Calvert Cliffs Nuclear Power Plant, Units 1 and 2
Renewed Facility Operating License Nos. DPR-53 and DPR-69
Docket Nos. 50-317 and 50-318

Subject: Response to Request for Additional Information to License Amendment Request - Revision to Technical Specification 5.5.7, Reactor Coolant Pump Flywheel Inspection Program

Response to Request for Additional Information
License Amendment Request
Revision to Technical Specification 5.5.7,
Reactor Coolant Pump Flywheel Inspection Program
Docket Nos. 50-317 and 50-318

Graph 1

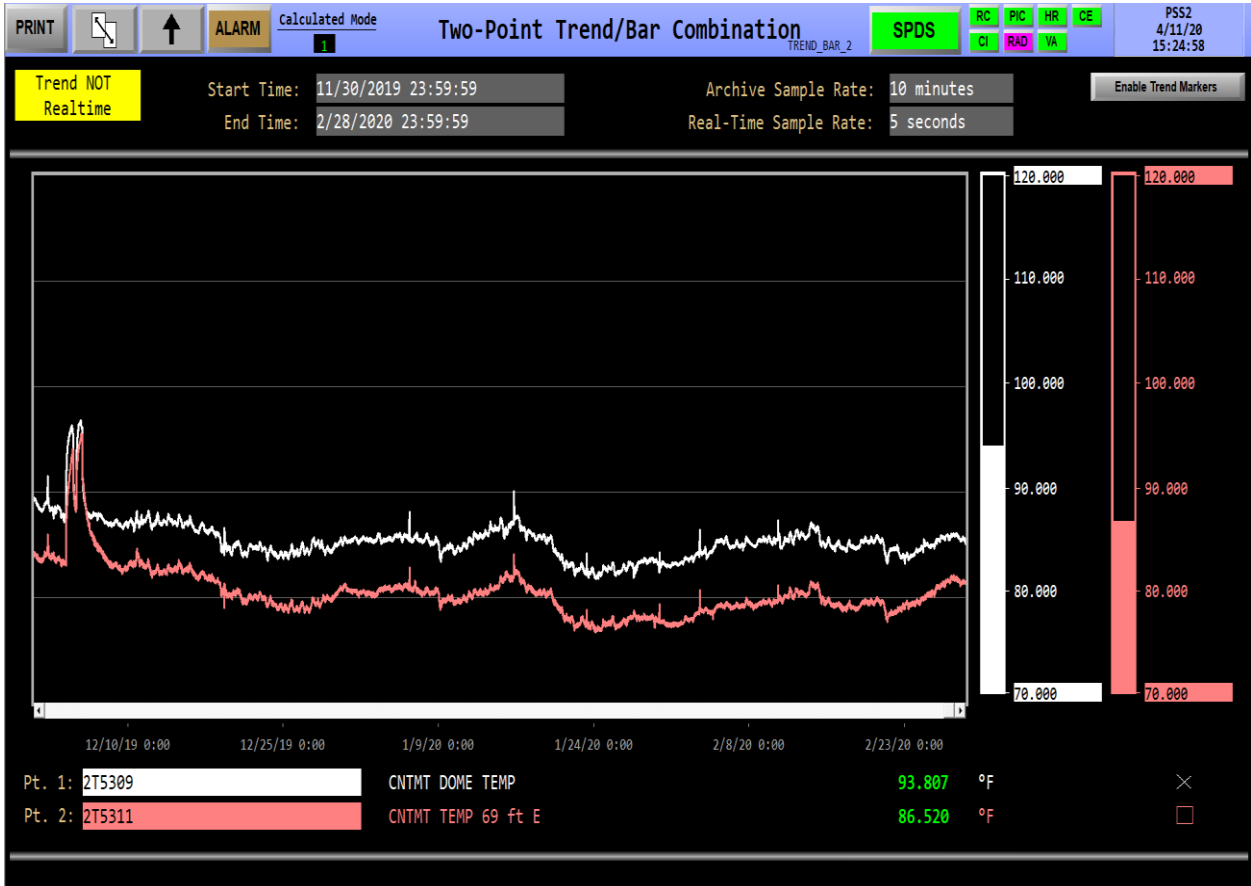
Provide a basis to confirm that the medium temperature will be 70°F or higher consistently, or provide the (RT_{NDT}) of the flywheel materials such that the medium temperature as described in the UFSAR, when coupled to (RT_{NDT}) values remain bounded by the TR.

Westinghouse, in calculating non-ductile critical crack length, conservatively chose to use 70°F as representing Calvert Cliffs ambient containment temperature. This value is conservative as it is below temperatures that are experienced in containment during unit operation at any time during the year.

Attached are graphs indicating the daily containment temperature during this past winter months as well as the daily containment temperature during summer months. From these attached graphs it shows that the choice of 70°F is conservative and is well below average containment temperatures experienced during operating conditions. Even with this conservative value, the calculation resulted in large critical crack lengths.

Graph 1 is taken from Unit 2 during operation this past winter (December 2019 through February 2020) and shows temperature in containment at the 69-foot elevation in containment and temperature near the top of containment dome. Containment temperatures during the coldest part of the year remained above 70°F.
